COMMENTS OF THE COUNCIL OF INDUSTRIAL BOILER OWNERS
on
EPA Proposed Reconsidered Rule
*National Emission Standards for Hazardous Air Pollutants for Major Sources: Industrial,
Commercial, and Institutional Boilers and Process Heaters*

EPA-HQ-OAR-2002-0058
76 Fed. Reg. 80598

February 21, 2012

Figure 1. Typical Biomass Fly Ash Particle Size Distribution⁴
 Note: Fly-ash means products of combustion

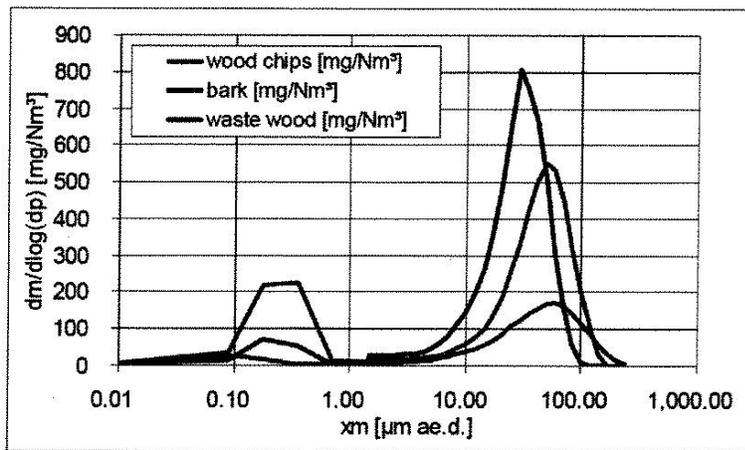
This is due to the vaporization of volatile ash species in the wood-like potassium and sodium biomass ash that yields a bimodal characteristic with peaks of nominally 0.5 and 20 to 40 microns. Coal ash, on the other hand, tends to exhibit a more mono modal distribution without the submicron peak. Data available for PM CEMs effective is primarily limited to coal, and data on how PM CEMS will respond to monitoring biomass emissions is expected to be problematic.

Beyond this, there are a number of correlation issues. For instance, the PM response to the light scattering instruments are very dependent on particle size, shape and even color. Other technologies have other limitations.

For the same reasons that it is not feasible to develop a meaningful correlation between the emissions being monitored by the PM CEMS instrument and particulate emissions in the stack, using the PM CEMS instrument technology as a PM CPMS will produce no repeatable and no meaningful results in situations where the characteristics of the stack emissions change due to changes in fuel mixtures, production rates and instrument correlation issues.

The output from a PM CPMS based on a PM CEMS instrument will simply be meaningless. Any time the fuel mixture changes, the instrument will go out of range even with no change to control device effectiveness or any meaningful change to emissions. This means that requiring use of a PM CPMS would be a very expensive waste of capital resources and would send both the regulated industry and the regulatory agencies on meaningless goose chases. Put quite simply, this technology will not work for its intended purposes.
